<b>CITY OF WESTMINSTER</b>			
<b>PLANNING APPLICATIONS COMMITTEE</b>	<b>Date</b> 27 October 2015	<b>Classification</b> For General Release	
<b>Report of</b> Director of Planning		<b>Wards involved</b> West End	
<b>Subject of Report</b>	<b>41 Farm Street, London, W1J 5RP</b>		
<b>Proposal</b>	Retention and relocation of plant and installation of associated acoustic enclosures on the rear second floor level		
<b>Agent</b>	Walsingham Planning		
<b>On behalf of</b>	Cirrus Inns Ltd		
<b>Registered Number</b>	15/01607/FULL 15/01608/LBC	<b>TP / PP No</b>	TP/2730
<b>Date of Application</b>	23.02.2015	<b>Date amended/ completed</b>	23.02.2015
<b>Category of Application</b>	Minor		
<b>Historic Building Grade</b>	Grade II Listed Building		
<b>Conservation Area</b>	Mayfair		
<b>Development Plan Context</b> - London Plan July 2011 - Westminster's City Plan: Strategic Policies 2013 - Unitary Development Plan (UDP) January 2007	Within London Plan Central Activities Zone  Within Central Activities Zone

41 FARM STREET, W1

**Proposal:** Retention and relocation of plant and installation of associated acoustic enclosures on the rear second floor level

**102**

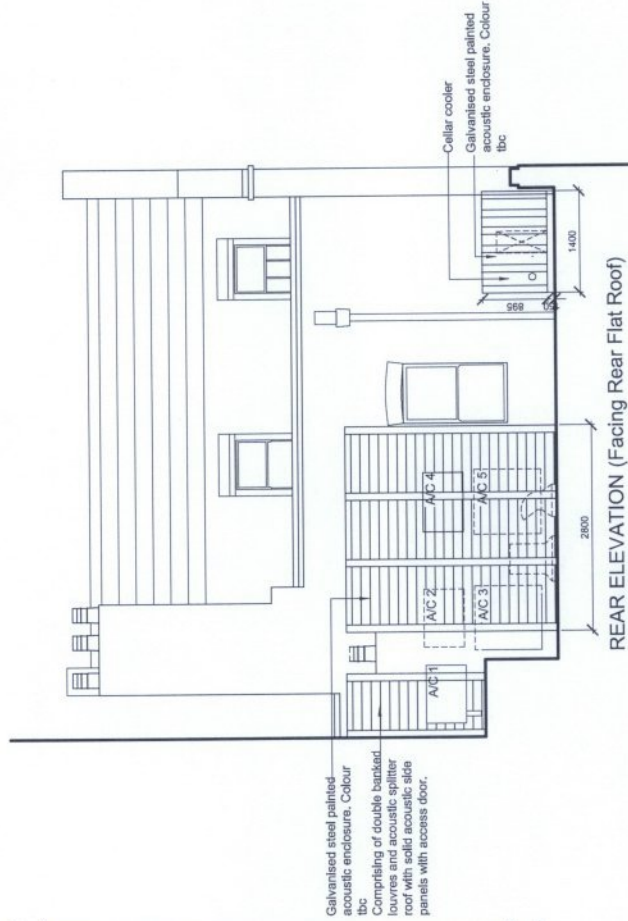
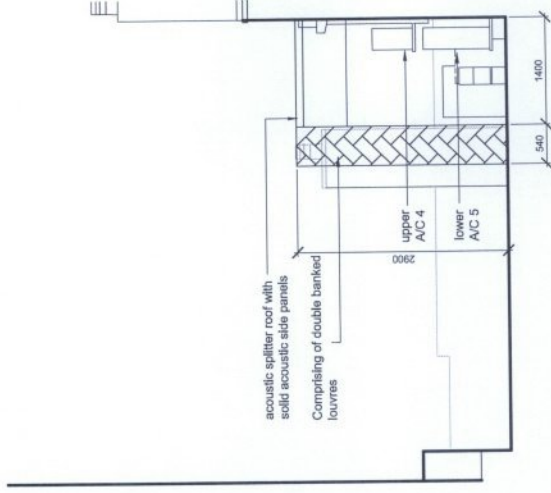
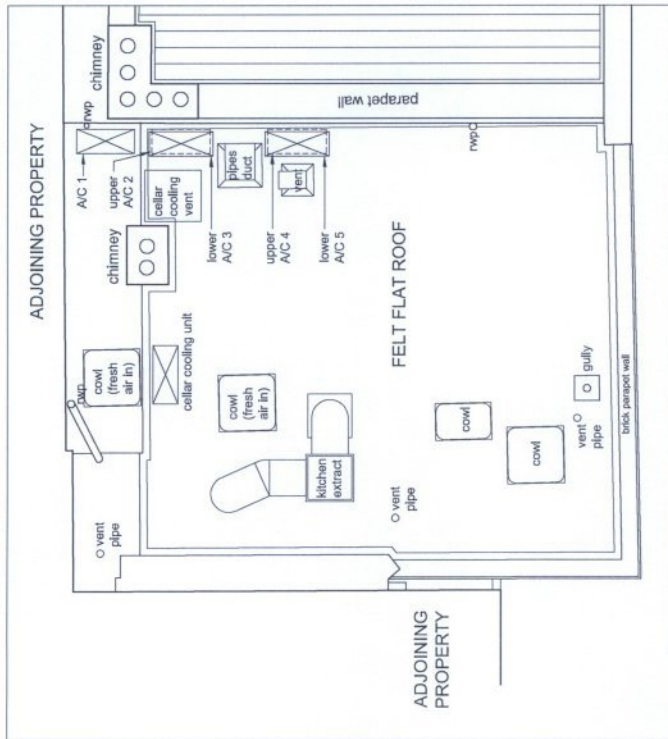
The area of the building on which the equipment is to be located is a later addition and the principle of installing equipment here is considered acceptable. However, the current proposal does not provide a suitable design for the visual screening; neither does it contain the plant within a suitable area of the roof.

The proposed plant is considered far worse in design terms than the existing arrangement. It is incongruous, creates clutter on the roof, and it is entirely alien to the architecture of the building. Furthermore, the detrimental effect of the plant is exacerbated by the proposed crude industrial screening which does absolutely nothing to ameliorating its visual impact.

The plant should be contained in one area to the rear of the roof with appropriate screening to ensure its visual impact is minimized and acceptable. If this is not possible, then the amount of plant should be reduced until it can be suitably screened.

An objection also refers to the poor quality of the drawings and the lack of relevant annotated dimensions and a scale. However, the proposed drawing includes a scale and relevant dimensions. It is considered sufficient information has been included on the drawings to show exact what is being applied for and permission could not be withheld on the grounds of this objection.

The plant should be located in a more suitable location on the roof with appropriate screening.
